TechBull 68

**Modifications Required for MDS-
2310 to MDS-9810 Piggy Back
(tail end) Installations**

Totalflow Technical Bulletin

Version 1.0, Revision AB (8 January, 2001)

MDS 2310/9810 Piggyback Cable for 6600/6400 and 6700 FCU when 9810 is configured for 1200 baud

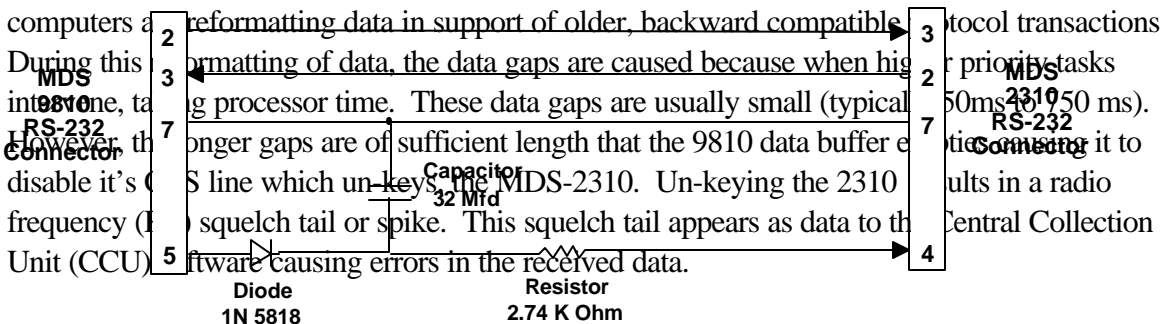
The MDS 2310/9810 piggyback configuration utilizes the presence of data on the 9810 to enable Clear-to-Send (CTS) on the 9810. The 9810's CTS line is connected to the Request-to-Send (RTS) input of the 2310. The presence of this control line (9810-CTS to 2310-RTS) keys and un-keys the 2310 based on the presence of data. The Totalflow Flow Computer Unit (FCU) doesn't always send seamless data. This is especially true when "New Database Capable" flow computers are reformatting data in support of older, backward compatible protocol transactions. During this reformatting of data, the data gaps are caused because when high priority tasks are executed on the processor, the processor time is taken away from the data processing. These data gaps are usually small (typical 50ms to 150ms). However, the longer gaps are of sufficient length that the 9810 data buffer empties. This results in a radio squelch tail or spike. This squelch tail appears as data to the Central Collection Unit (CCU) software causing errors in the received data.

To date, the most reliable solution requires a special cable between the MDS-2310 and MDS-9810 at the piggyback location (See wiring above). This cable includes a capacitor that prevents the RTS signal from dropping on the 2310 when data gaps occur. Other changes required include:

Piggyback programming: Program 9810 to "CTS Key", CTS=15 ms (default), Buffer=Off and baud rate=4800 on MDS-9810 connected to MDS-2310. On the MDS-2310 set the soft carrier dekey= 4 ms.

- MDS-9810 Piggy back radio, program "CTS Key", CTS delay=15ms, Buffer=off and Baud Rate=4800
- MDS-2310 Piggy back radio, program Soft Carrier Dekey = 4 ms and baud rate = 4800
- MDS-9810 Tail End links, CTS delay=10ms and Baud Rate=1200
- Program Tail End Flow Computer Baud rates to 1200 baud

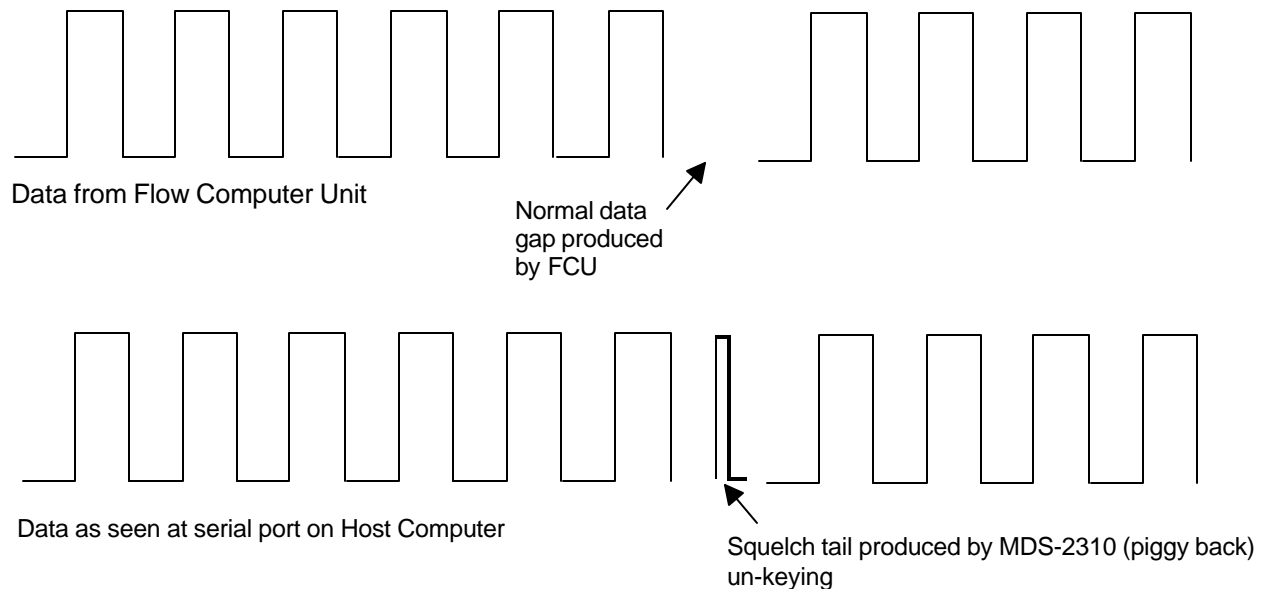
9810 Remotes: CTS=10 and baud rate=1200. Also program Flow Computers on tail end 9810 links to 1200 baud.
